# SCMVX008-01A

## S E R V I C E N O T E

### SCMVX008 Option 040 or VX008-66501 4 Channel DDC TIM Module (PAWN)

**Descriptive title:** SCMVX008 Option 040 High LO Feed thru - Spur at CF

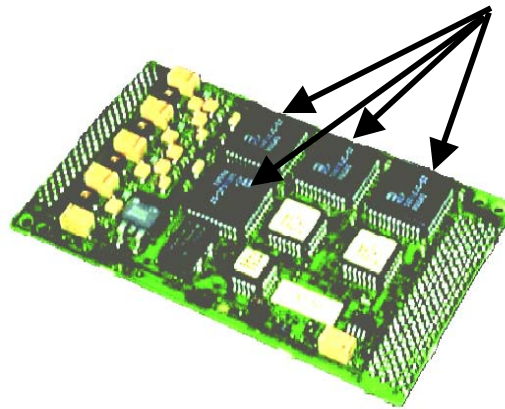
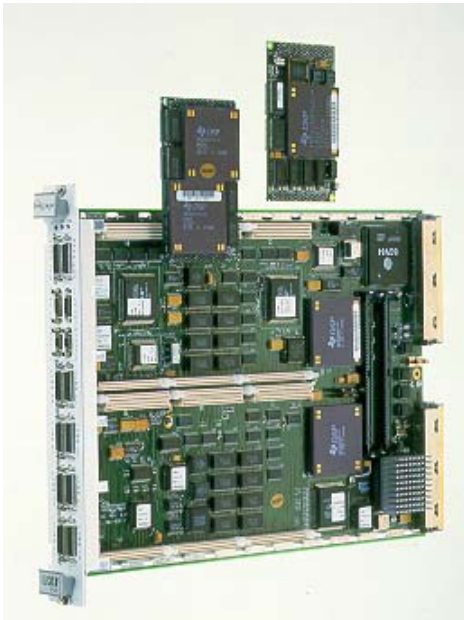
**Serial Numbers:** Any Harris chips with date codes less than: N0014, replace VX008-66501  
Date Code format is: NYYWW (YY = Year WW = Week Number)

4 Harris chips can be found on the VX008-66501 DDC TIM Module:

Customer may complain of high LO feed thru (spur at CF) or about a steady tone when demodulating signals of interest. There are 4 Harris Chips used on the VX008-66501 DDC module. Earlier date codes of these Harris chips had a LO feed thru problem. Agilent compensated for this problem with software patch. Now Harris has fixed this LO feed thru spur and Agilent's software patch cause this LO feed thru spur to re-appear. Most customers do not care about LO feed thru because of the demodulation algorithm used. Only customers performing USB or LSB demodulation will notice this, so very few customers should report this as a problem.

If customer calls and complains of high LO feed thru spurs, spur at center frequency or a steady tone after USB/LSB demodulation. Replace customers VX008-66501 - 4 channel DDC TIM Module. Module replacement can be done by the customer or by an Agilent service center.

The customer may have to modify his code to remove the Agilent software patch that compensated for the original bad Harris chip.

1. Search for the following variable in your C40 downloadable code: State.DcBuckout
2. Insert the following line of code above this line: State.DCBuckout = 0;
